The Preliminary Plat review has been completed and all revisions shall be shown using the Conditional Final Plat Review Application. The revised plat, the checklist, and a response letter shall be uploaded to application.

Comments with the P & E prefix are to be addressed as part of the Plat Review.
Comments with the CE prefix will be addressed during the Engineering Review of the construction documents

The Enclave at YOLy
PREPARATION DATE: JUNE 1, 2023
SHEET 1 OF 3

AN ADDITION TO THE CITY OF BROKEN ARROW, TULSA COUNTY, STATE OF OKLAHOMA, BEING A SUBDIVISION OF THE S/2 OF THE NW/4 OF SECTION 9, T-17-N, R-14-E, OF THE INDIAN BASE AND MERIDIAN.

LOCATION MAP

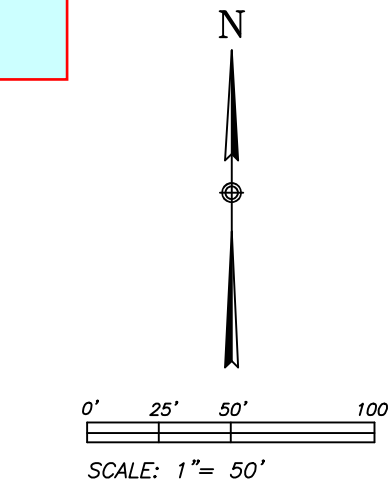
E-02
Location map does not match the plat limits.

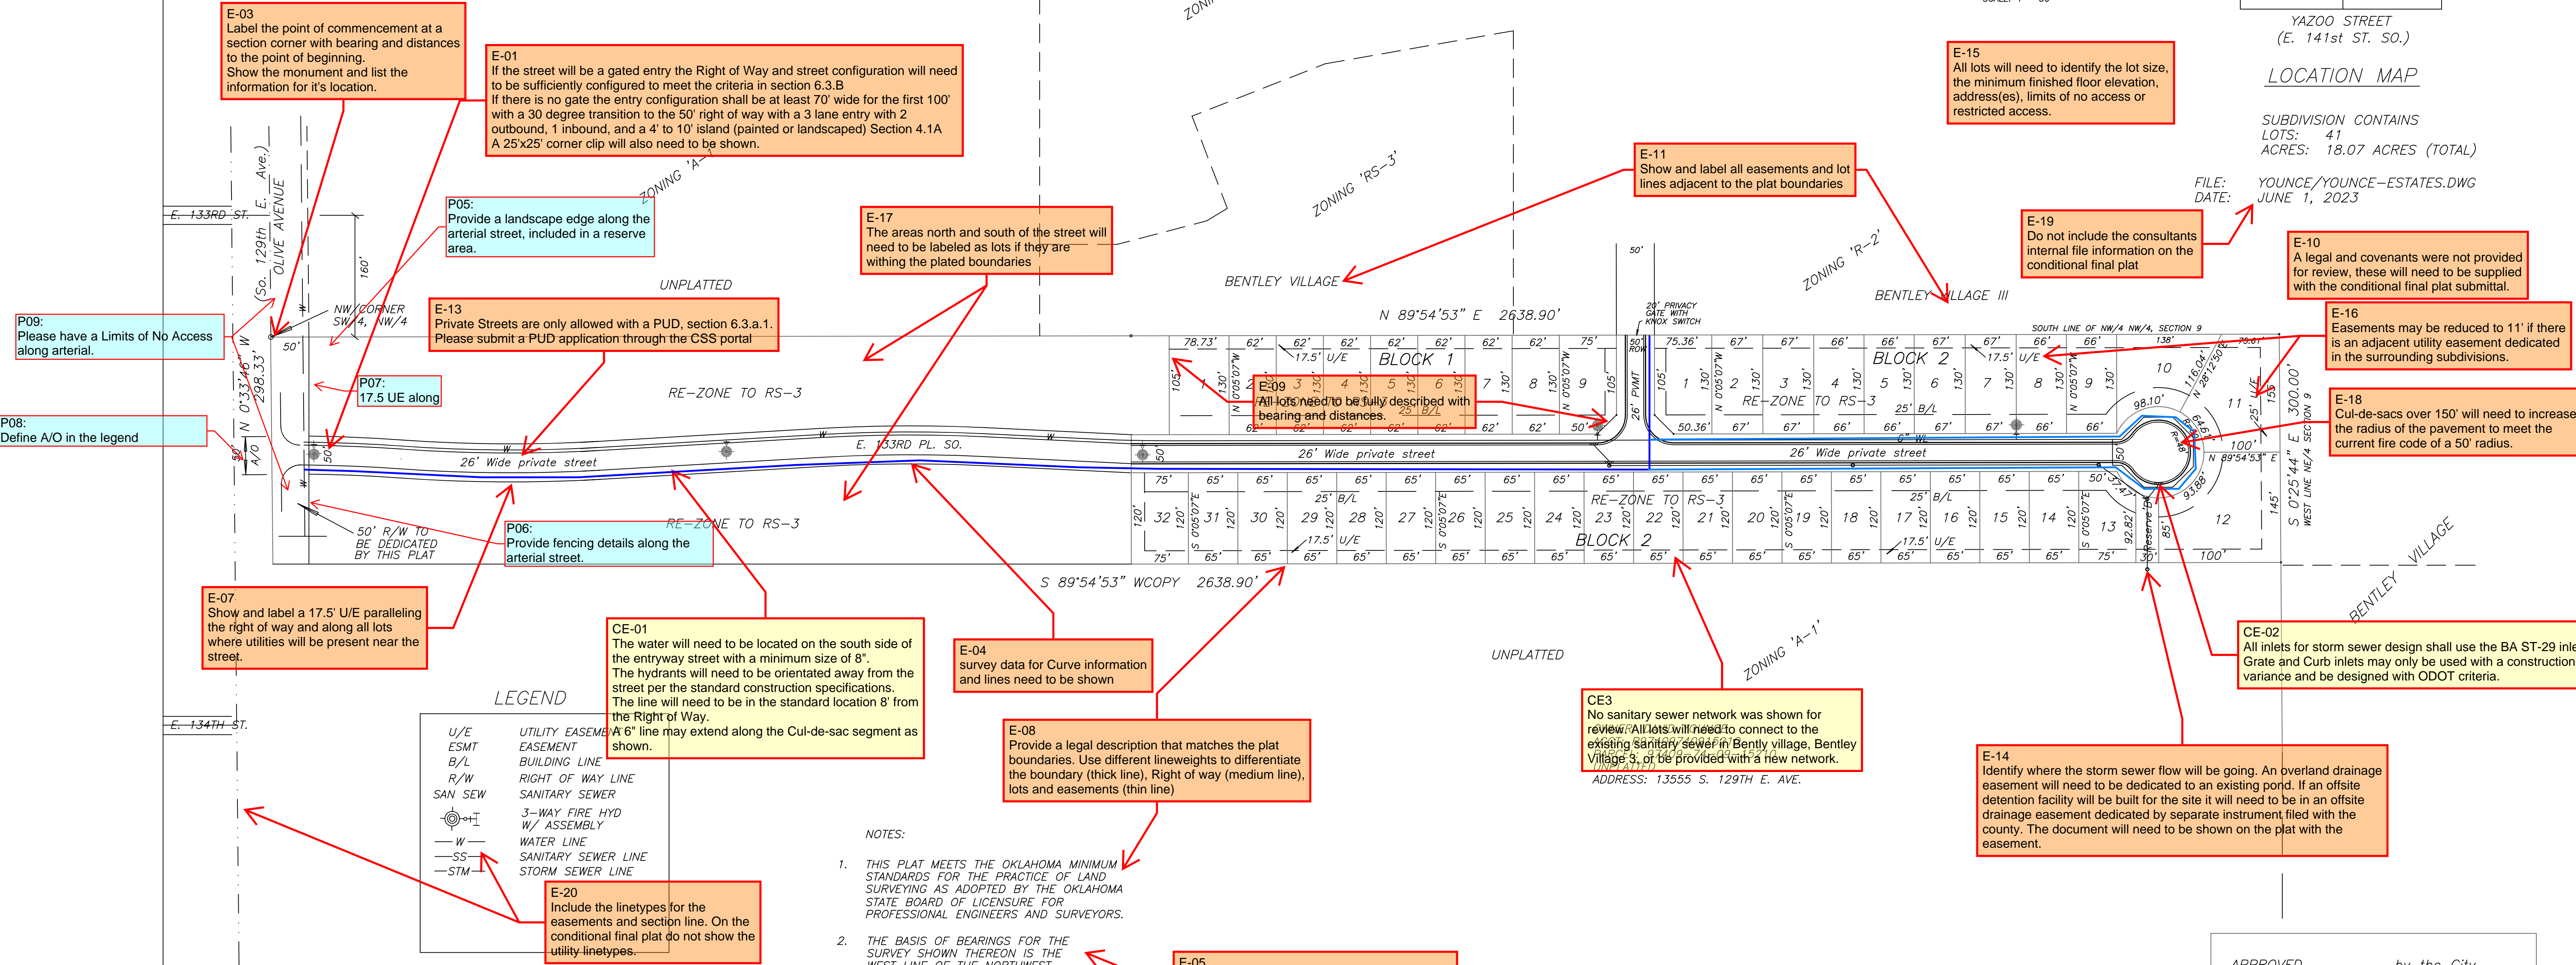
P08:
Label Reserve A, and also include the private streets in a reserve area.

P10:
sidewalks are required along all frontage roads, and reserve areas.

E-16
Easements may be reduced to 11' if there is an adjacent utility easement dedicated in the surrounding subdivisions.

E-18
Cul-de-sacs over 150' will need to increase the radius of the pavement to meet the current fire code of a 50' radius.

E-14
Identify where the storm sewer flow will be going. An overland drainage easement will need to be dedicated to an existing pond. If an offsite detention facility will be built for the site it will need to be in an offsite drainage easement dedicated by separate instrument filed with the county. The document will need to be shown on the plat with the easement.

CE3
No sanitary sewer network was shown for review. All lots will need to connect to the existing sanitary sewer in Bentley village, Bentley Village 3, or be provided with a new network.
ADDRESS: 13555 S. 129TH E. AVE.

E-04
survey data for Curve information and lines need to be shown

E-08
Provide a legal description that matches the plat boundaries. Use different lineweights to differentiate the boundary (thick line), Right of way (medium line), lots and easements (thin line)

E-05
All plats need to be tied into the Oklahoma North State Plane coordinate system.

E-06
All monuments used to establish the plat need to be shown, identified, and described.
